**Package Summary and Requirements**

**PROPOSER'S ACKNOWLEDGEMENT FOR PACKAGE 18**

TYPE OF USE: AVAILABLE AREA  
 TERMINAL LOCATION: D  
 REFERENCE NUMBER: **GATE D23-D24**  
 DESIGN CONDITION:  
 CONTRACT NUMBER:

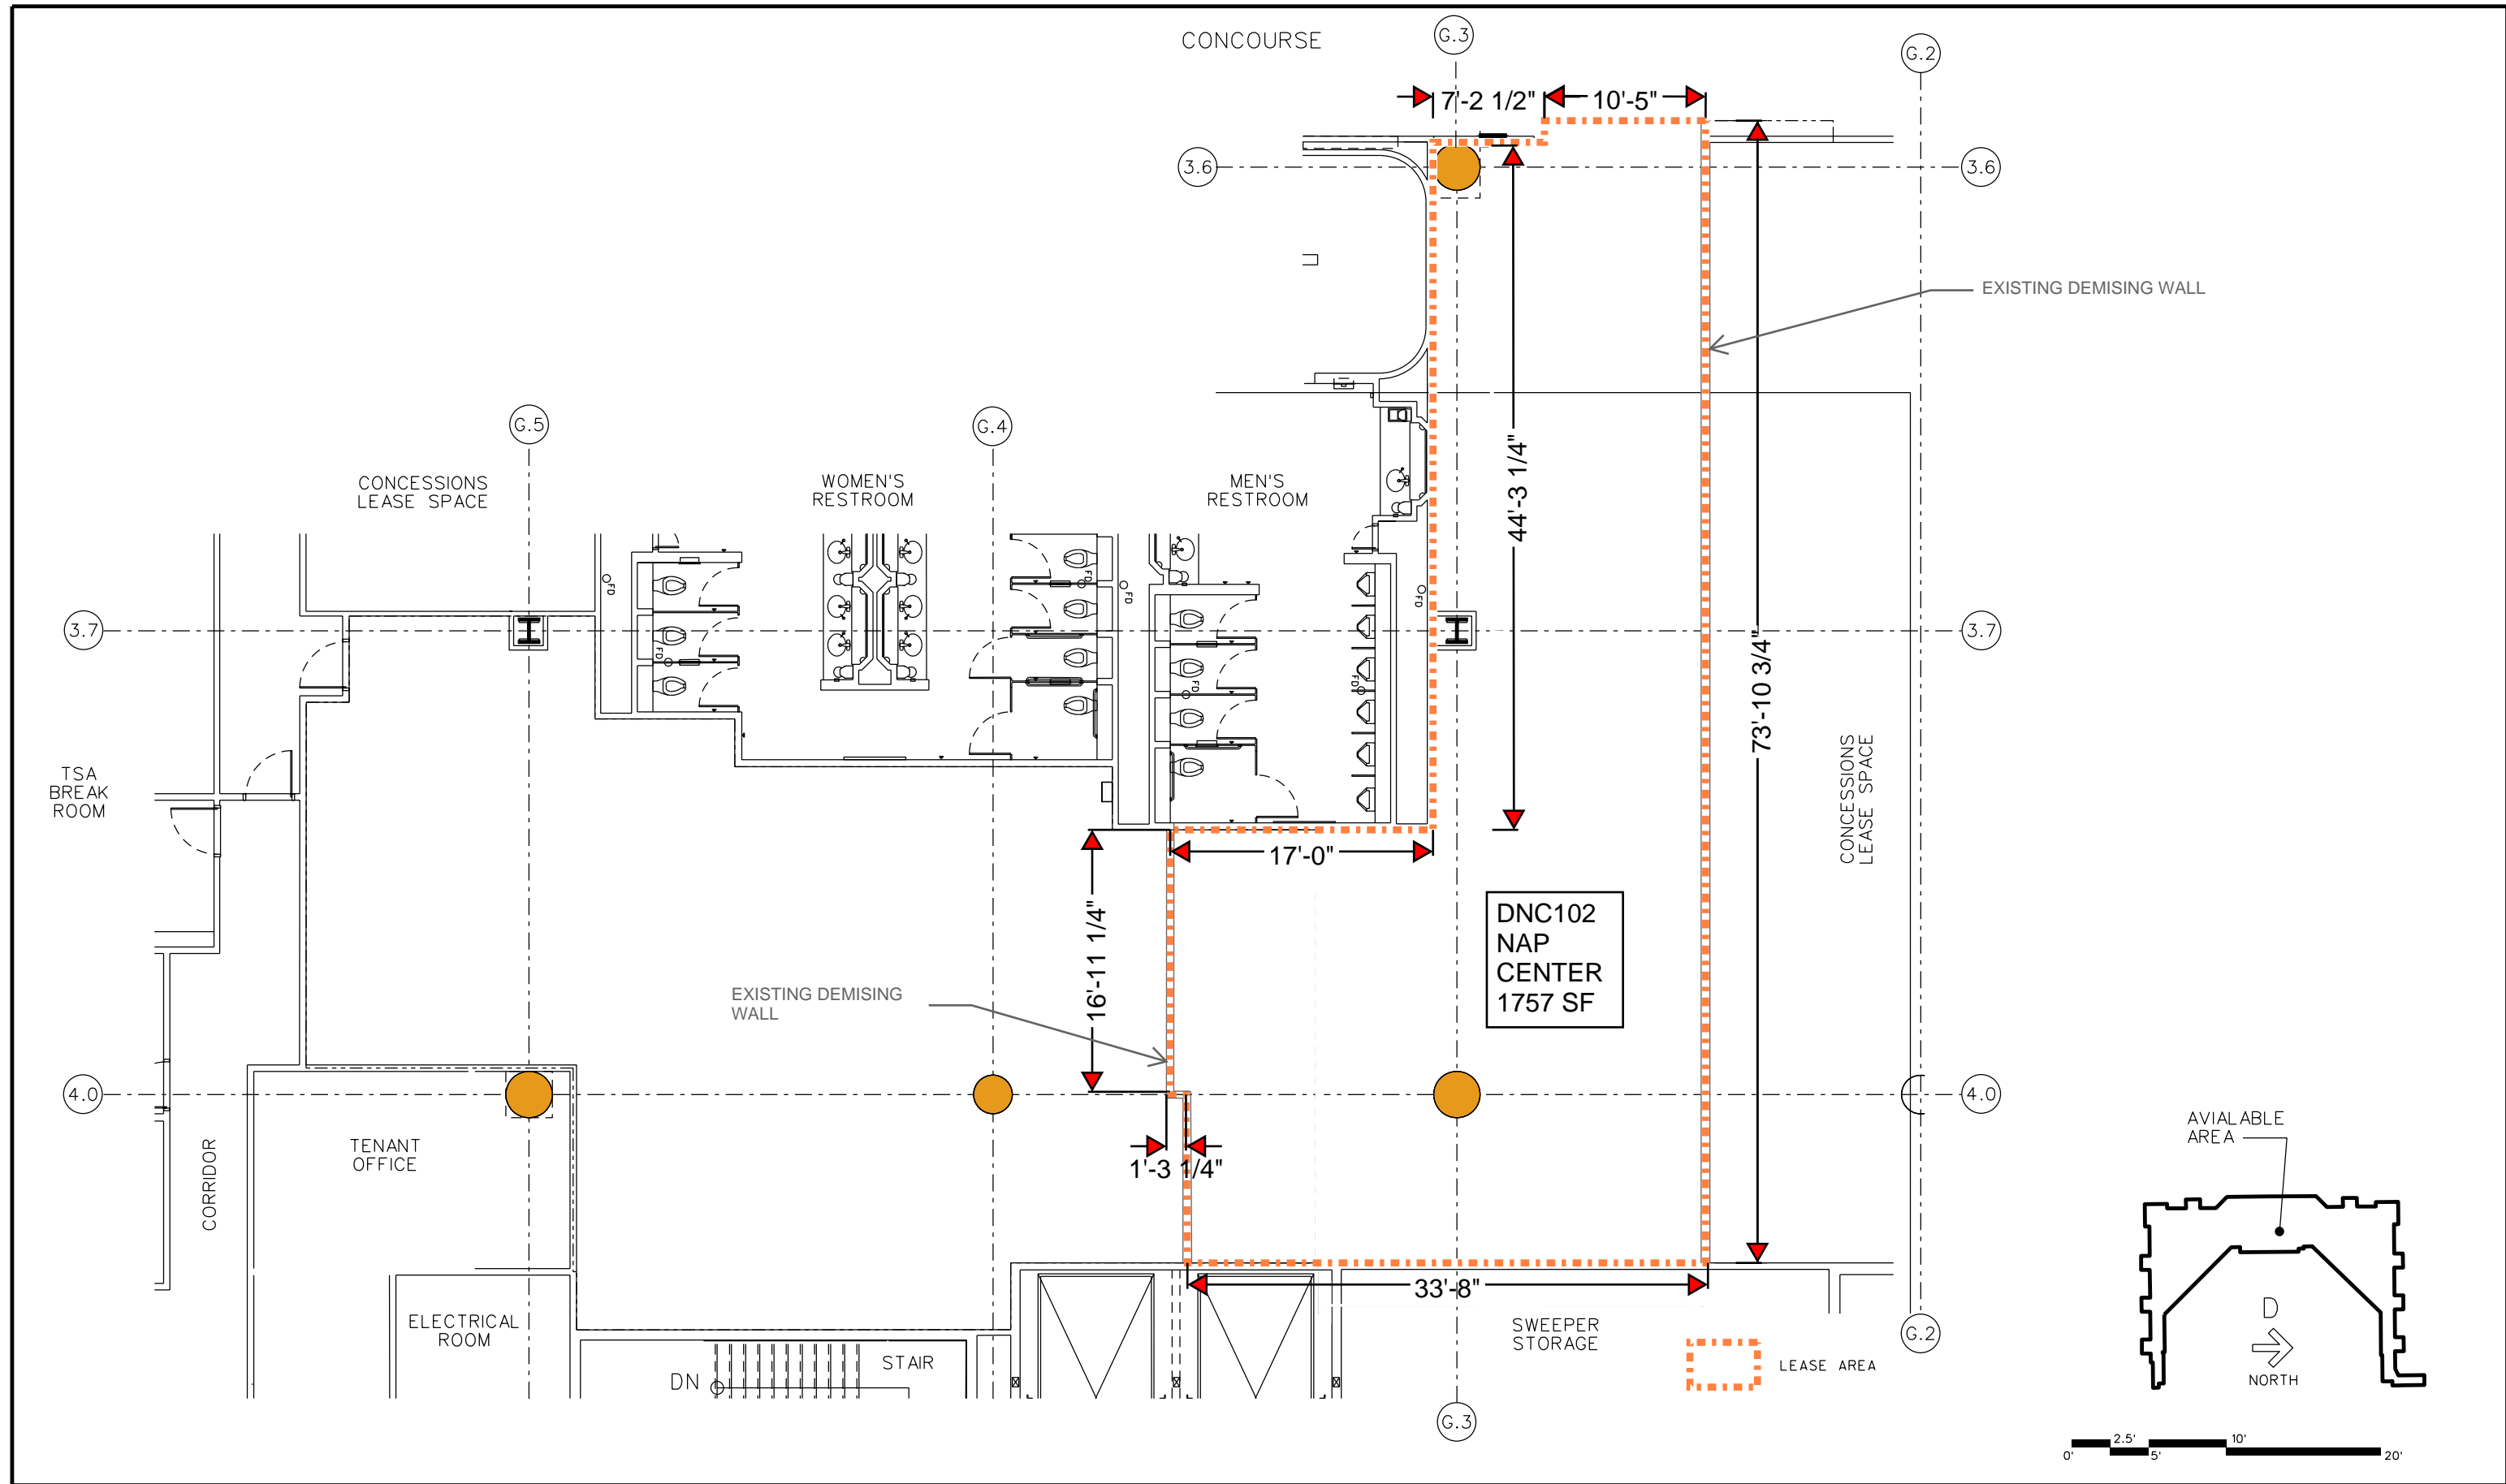
<b>Space Identifier</b>	<b>Near Gate</b>	<b>Proposed Concept</b>	<b>Square Footage</b>	<b>Term in Years</b>
D-NC102	D24	Nap Center	<del>2,344</del> <u>1,757</u>	7 years
